City of Portland, Maine - Building or Use Permit Application

Permit No: 08-0276	Issue Date:	CBL: 087 Z006001
-----------------------	-------------	---------------------

Past Use: Single Family Home	Proposed Use: Single Family Home - Adding playroom to attach house to garage. Changing existing garage to bedroom, rebuild porch, interior renovations	Permit Fee: \$820.00	Cost of Work: \$80,000.00	CEO District: 1
Proposed Project Description: Adding playroom to attach house to garage. Changing existing garage to bedroom, rebuild porch, interior renovations		FIRE DEPT: <input type="checkbox"/> Approved <input checked="" type="checkbox"/> Denied	INSPECTION: Use Group: 12 3 Type: SB	
		Signature: <i>[Signature]</i>		
PEDESTRIAN ACTIVITIES DISTRICT (P.A.D.)				
Action: <input type="checkbox"/> Approved <input type="checkbox"/> Approved w/Conditions <input type="checkbox"/> Denied				
Signature: _____ Date: _____

From: Ann Machado
To: Gerald Weinand
Date: 4/2/2008 1:02:18 PM
Subject: Re: Bergh 70 Luther Street Peaks

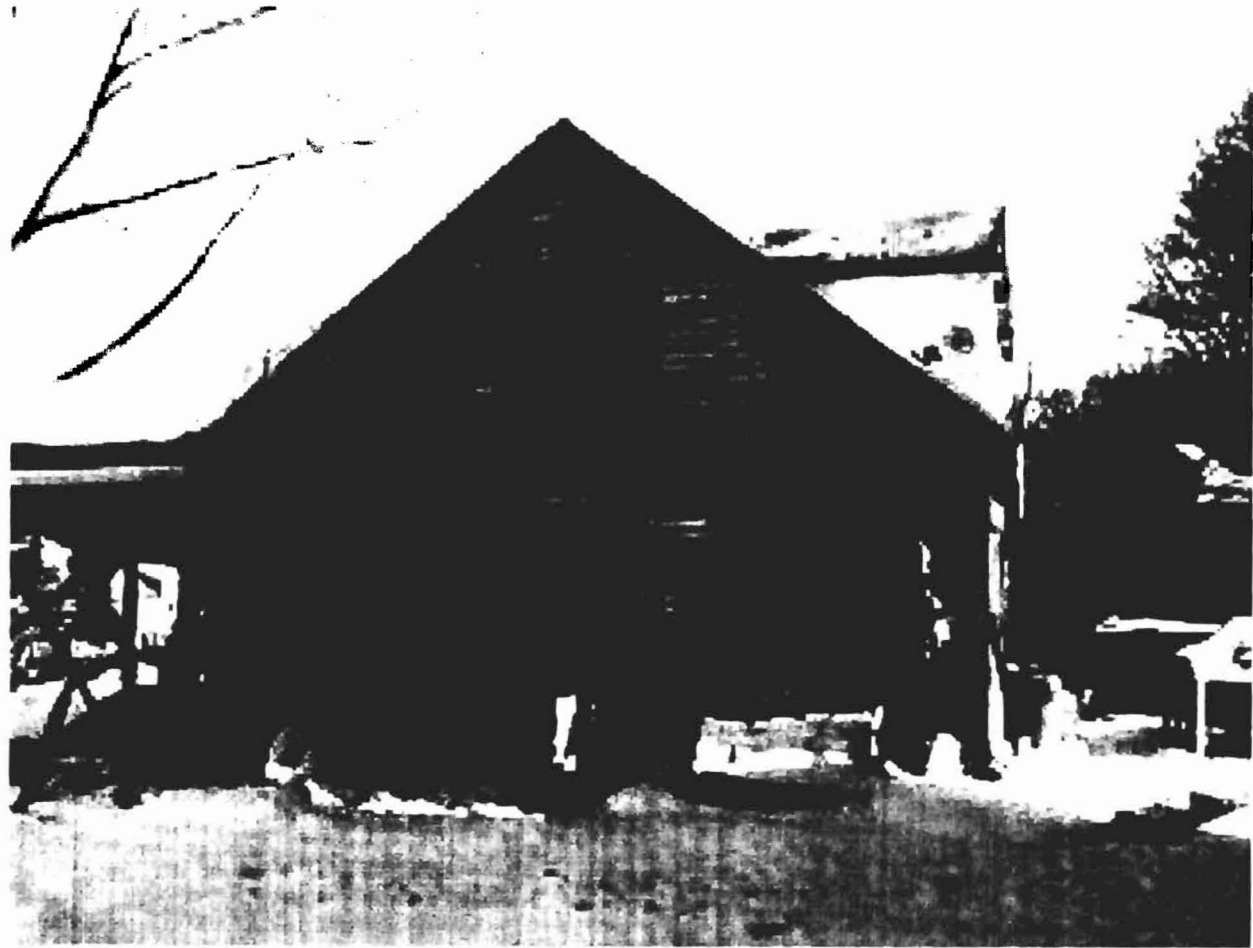
- 2) Your side porch is presently legally nonconforming as to the front setback. If you rebuild it in a smaller footprint then you will lose part of the footprint that is legally nonconforming now. The rebuilt porch must be the same height and have the same roofline as the existing porch.

- 3) As discussed during the review process, the property must be clearly identified prior to pouring concrete and compliance with the required setbacks must be established. Due to the proximity of the setbacks of the proposed addition, it may be required to be located by a surveyor.

4/4/2008-amachado: Received revised plot plan from Gerald Weinand. According to Gerald, the extension of the shed dormer in the front is adding a minimal amount of space since the kneewall now is at 3'11", and the dormer in the rear is just adding head room over the stairs.

1 SECOND FLOOR PLAN

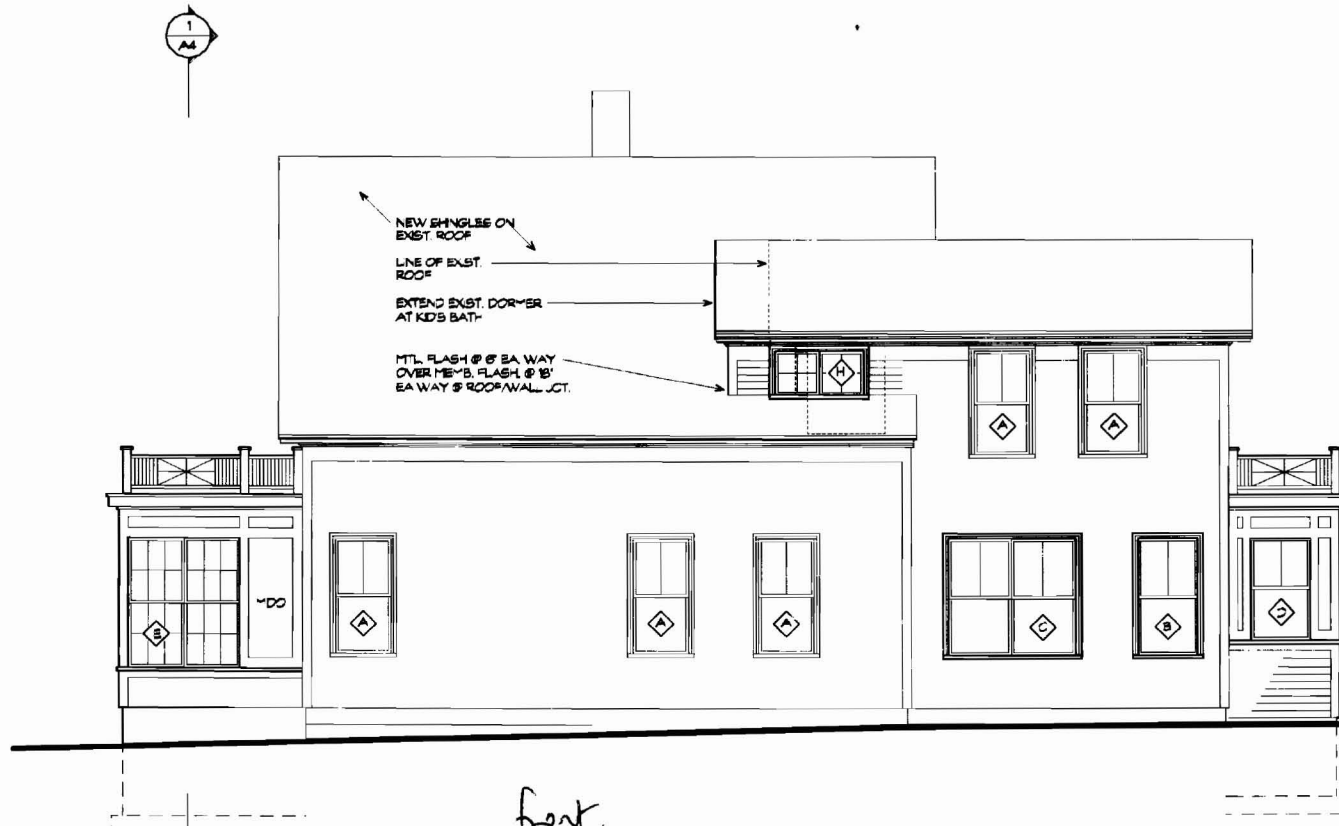
4/2/2008-amachado: Spoke to Gerald W., the architect. He will submit a plot plan that reflects what is there and what is being added. He will send photos of the existing garage. The front dormer is being extended three feet. The new shed dormer on the rear is about 8'.

I need to call you about the calculations on the extension to the front dormer.

Regarding the knee walls, the one in the Bath where the dormer is to be extended is 3'-11" high. The new area under the dormer is 48 inches wide, and so the increased floor area is one-half of a square foot.

Since the front of the existing house is nonconforming, the existing house is nonconforming to the setback so section 14-436(b) applies for the dormer on the rear too.
